Access Compliance Report Public Rights-of-Way (Curb Ramps)

Main Street: GRAMERCY_DR Cross Street: ESPLANADE_AVE Location: NW

ADA ID: RPAT211025115200 Ramp Type: Type 4 - Parallel Initial Pass/Fail: Fail Overall Compliance: No Severity Score: 15

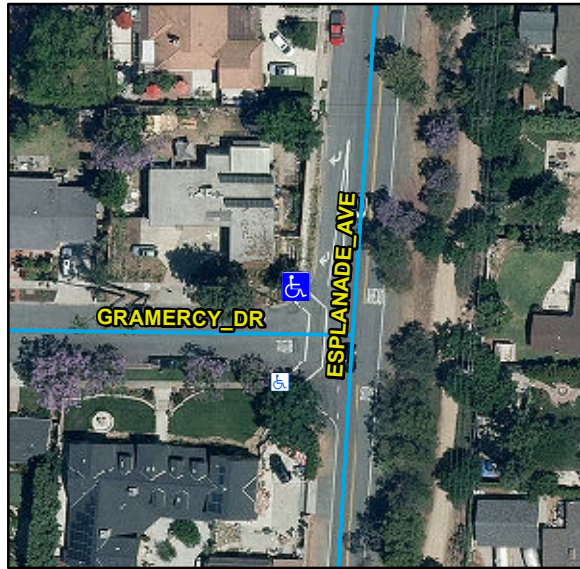
Compliance	Description	Data	Compliance	Description	Data
N/A	Ramp Length LT (in)	74	N/A	Ramp Length RT (in)	102
Yes	Ramp Width LT (in)	76	Yes	Ramp Width RT (in)	53
No	Ramp Run Slope LT (%)	9	Yes	Ramp Run Slope RT (%)	8.2
Yes	Ramp Cross Slope LT (%)	1.8	Yes	Ramp Cross Slope RT (%)	1.4
N/A	Landing Present	N/A	N/A	DWS Provided	N/A
N/A	Landing Length (in)	N/A	N/A	DWS Contrast	N/A
N/A	Landing Width (in)	N/A	N/A	DWS Length (in)	N/A
N/A	Landing Run Slope (%)	N/A	N/A	DWS Full Width	N/A
N/A	Landing Cross Slope (%)	N/A		DWS Offset Type	N/A
N/A	Landing Movement Obstructed?	N/A	N/A	DWS Offset Left (in)	N/A
	Landing Movement Type	N/A	N/A	DWS Offset Right (in)	N/A
N/A	Landing Shared	N/A			
N/A	Clear Space	N/A			
N/A	Clear Space To Crosswalk (in)	N/A			
N/A	Marked Crosswalk 1	Yes	N/A	Marked Crosswalk 2	N/A
	Crossing 1 Direction	S		Crossing 2 Direction	N/A
	Marked Crosswalk 1 Width (in)	120		Marked Crosswalk 2 Width (in)	N/A

Remove & Replace Entire Ramp.

R304.3.2, STD 1115
